Project Erebus: Supplementary Environmental Information Addendum Report

1.1 Request for Further Information

- 1.1.1.1 This report has been produced in response to Natural Resources Wales (NRW) Marine Licensing's request, email dated 29 June 2022, for further information under the Marine Works (Environmental Impact Assessment) Regulations 2007 (as amended) for Marine Licence application ORML2170 Project Erebus. The Project is a demonstration scale Floating Offshore Wind (FLOW) development in the Celtic Sea region, proposed by the developer, Blue Gem Wind (BGW), a joint venture between Simply Blue Energy (SBE) and TotalEnergies.

Figure 7-4: Analysis of tanker loitering at different speeds.

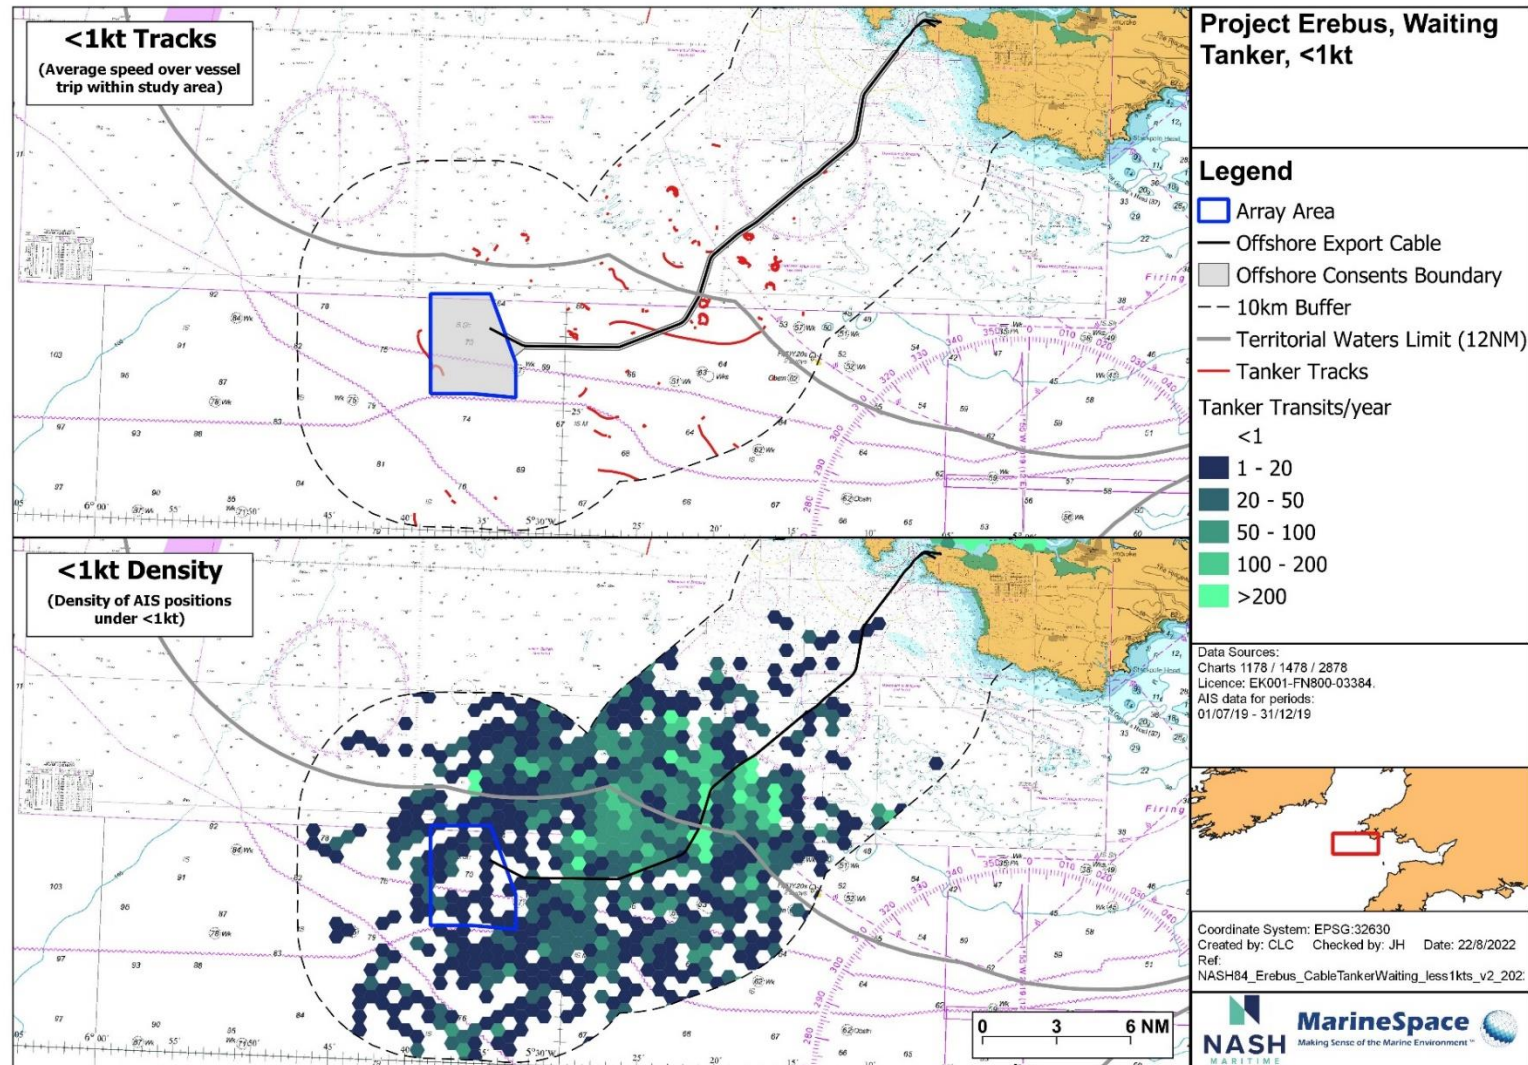
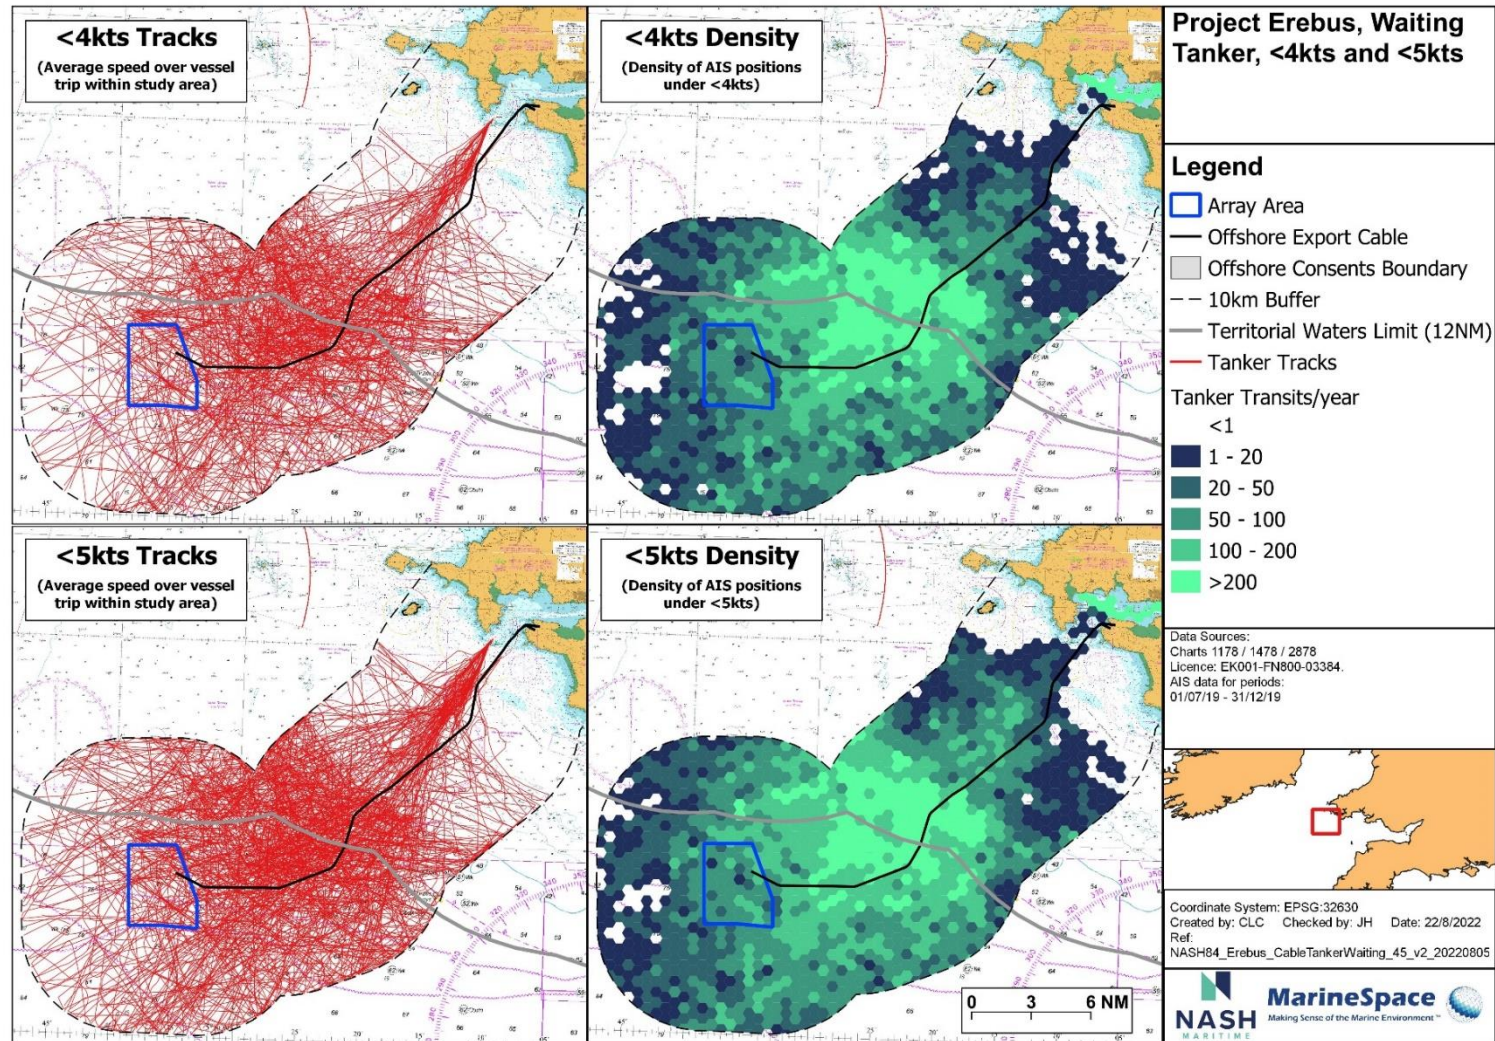
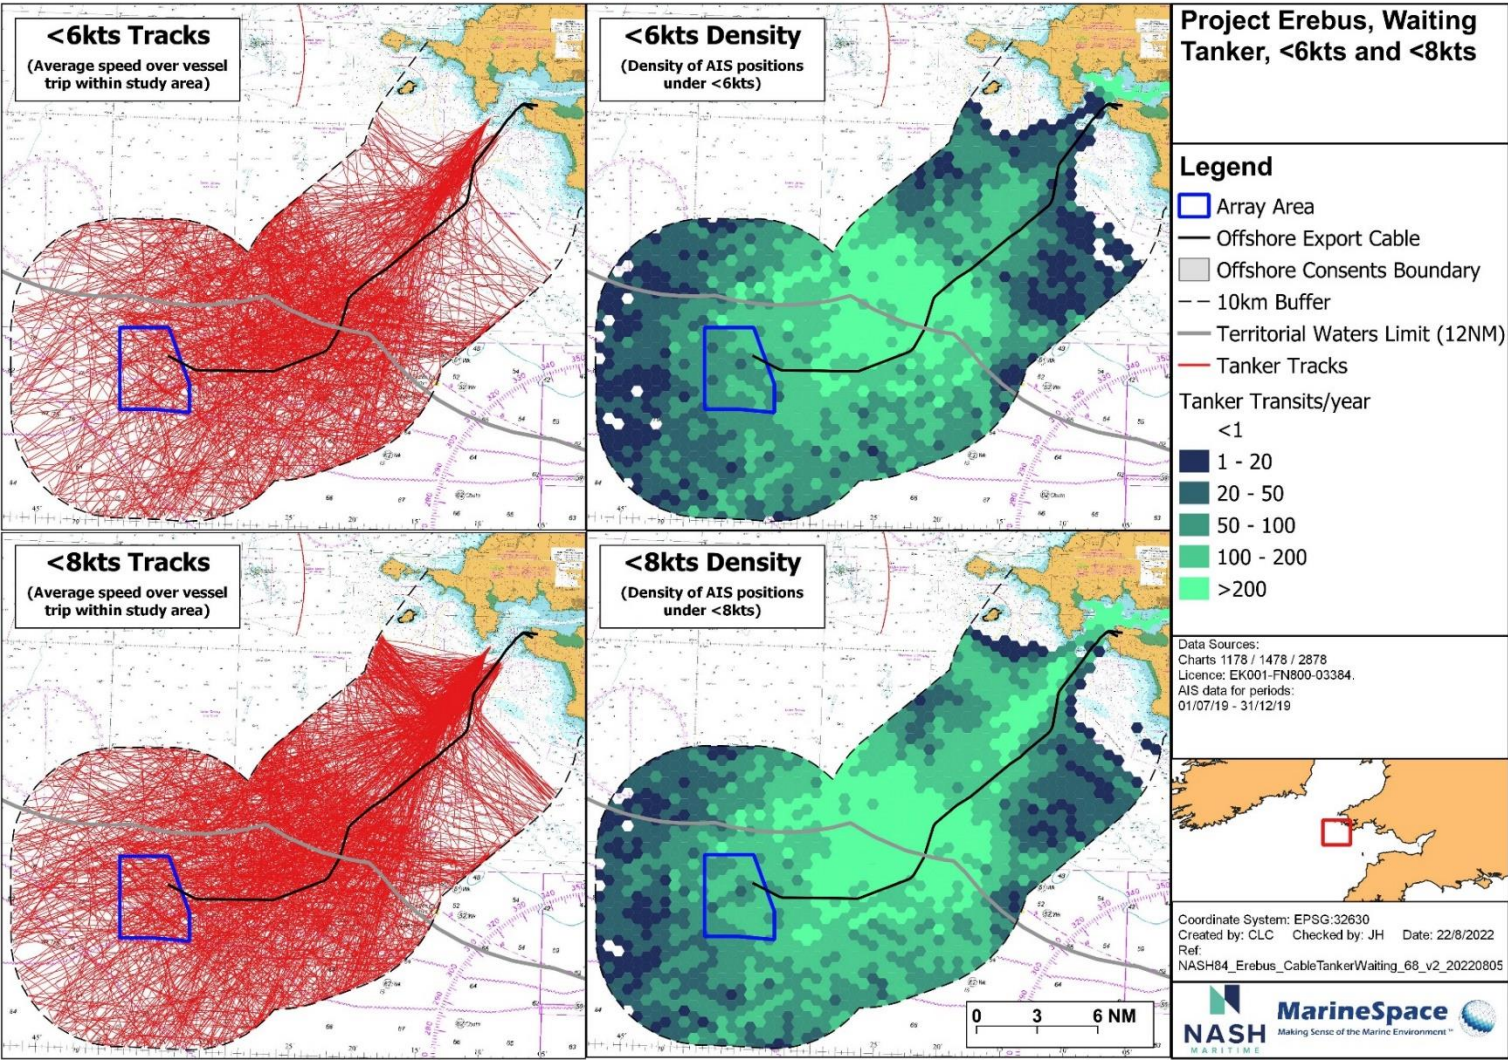
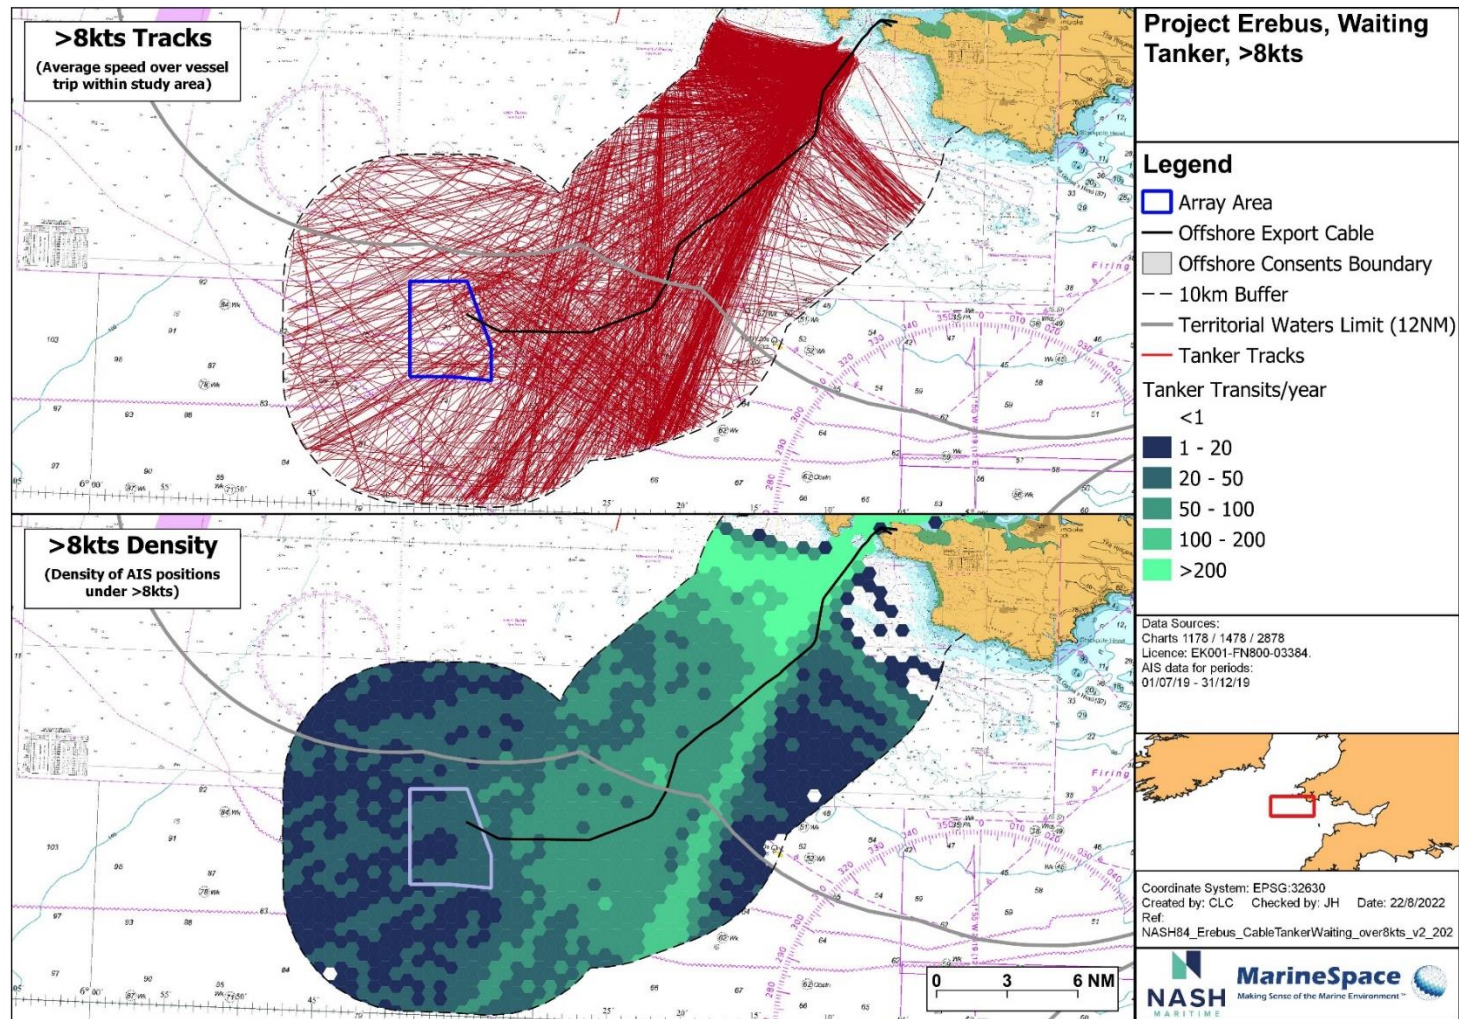
- 7.3.1.2 Whilst the CoS have suggested that a lower speed threshold should be utilised, sensitivity analysis undertaken by NASH Maritime with lower thresholds did not meaningfully alter the interpretation of these activities. Given the risk profile associated with loitering vessels, it is considered that the choice of a higher speed threshold of 8kts is more conservative and precautionary than a lower limit. Figure 7-4 to Figure 7-7 provide a breakdown by a range of speeds less than 8 kts, to show findings from additional analysis.

Figure 10-1: Map showing the Project site, and all of the nature conservation sites screened into assessment for Annex II marine mammal receptors.

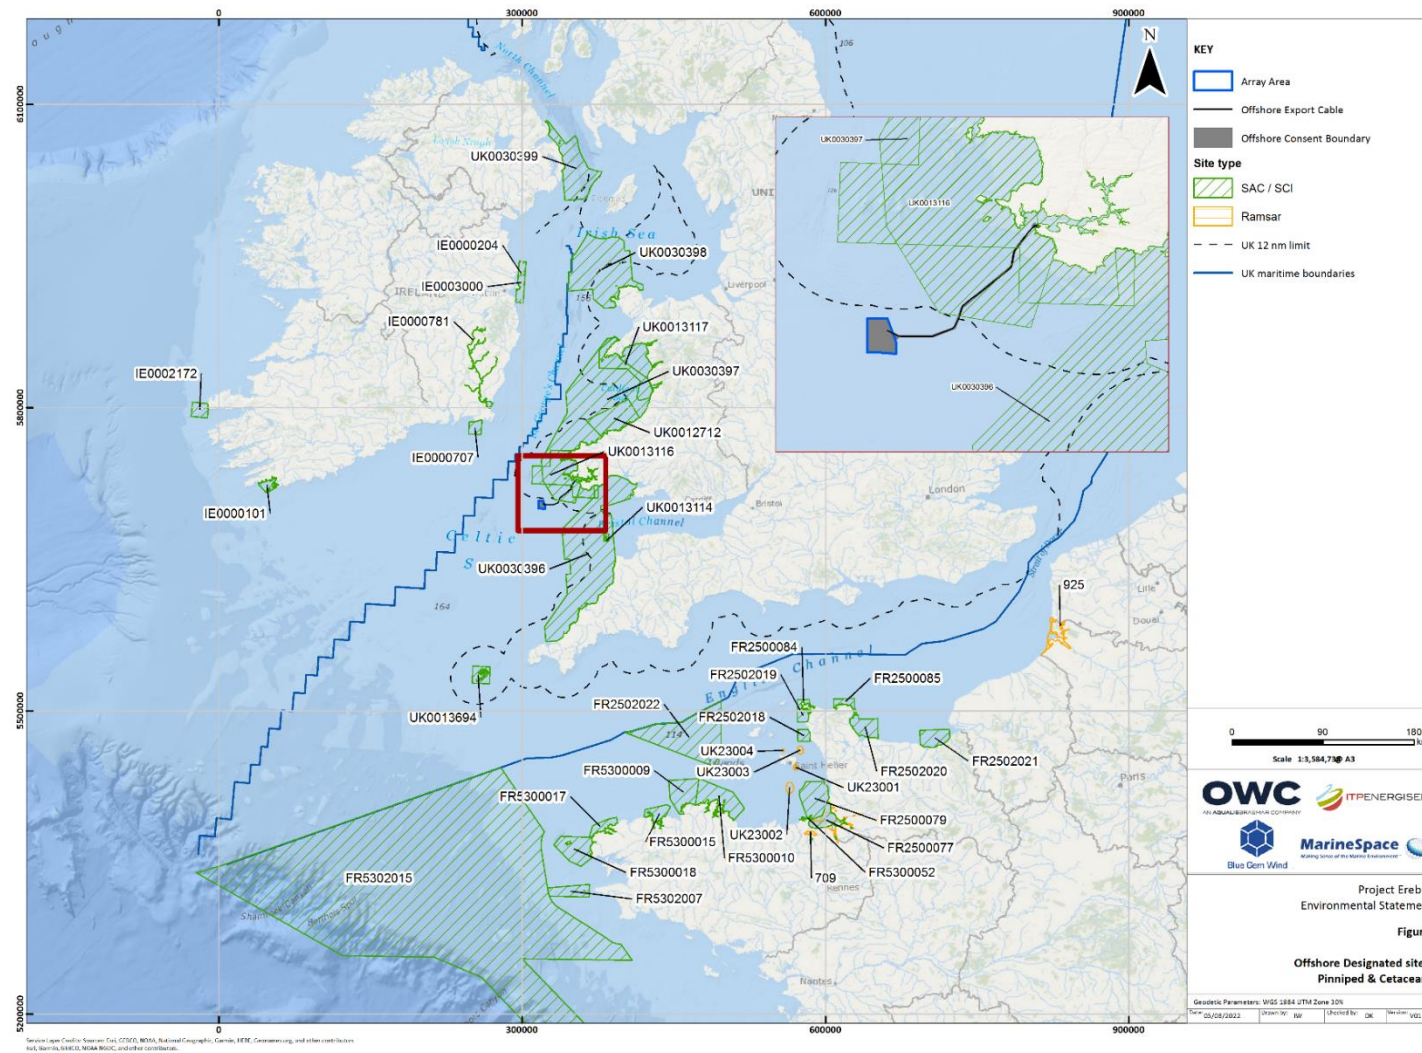
10.2.2.2 It is unclear which list of sites is being referred to in this comment. In line with NRW (2020a) guidance, all sites within the appropriate MMMU were screened into assessment (Figure 10-1). However, an iterative approach was then adopted, where assessment is carried out for the closest site to the Project footprint. If an Adverse Effect On Site Integrity (AEOSI) was determined, then assessment was carried out for the next closest site. If no AEOSI was determined, more distant sites were not considered further.
